## Customer Service Bulletin Commercial Business Group

**Greensmaster® 3050, 3100, 3150**

**Subject: Bumper (94-4548) may damage Cutting Unit Grass Shield.**

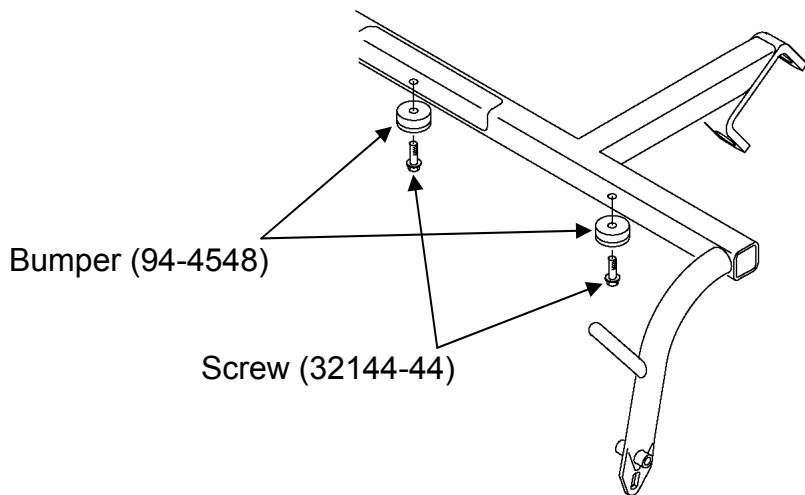
Beginning in 2003, the carrier frames were equipped with Bumper (94-4548), however their purpose was not clearly identified in the manual. These bumpers are only intended to be used with DPA Cutting Units (Model 04610 and 04611). If your greensmower is equipped with other cutting units, these bumpers must be removed or damage to the cutting unit grass shield may result. Use the illustration below as a reference.

Remove Bumpers from Carrier Frames when installing Cutting Units other than Models 04610 or 04611.

Examples: 04470, 04471, 04472, 04473, 04404, 04406, 04408, 04450, and 04468.
